The Civic Society For Milton Keynes

# **MILTON KEYNES OPEN SPACE ASSESSMENT**

**A Response to  
the Consultation by  
Milton Keynes Council**

**January 2018**

## DOWNS BARN

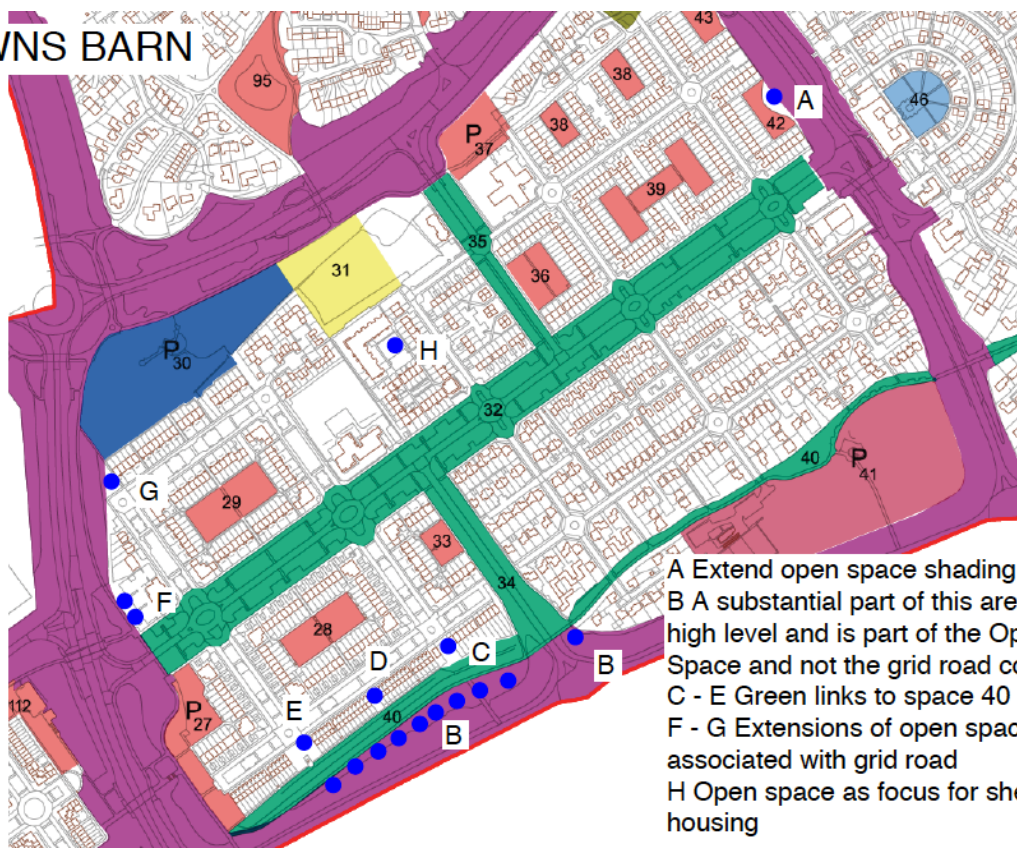
We have included on the following pages comments upon the existing plans for some gridsquares with which some of our members are familiar, and which show spaces that they feel to be important but which have been excluded. It is not intended to be an exhaustive survey of the city but it illustrates some of the concerns that have been referred to above.
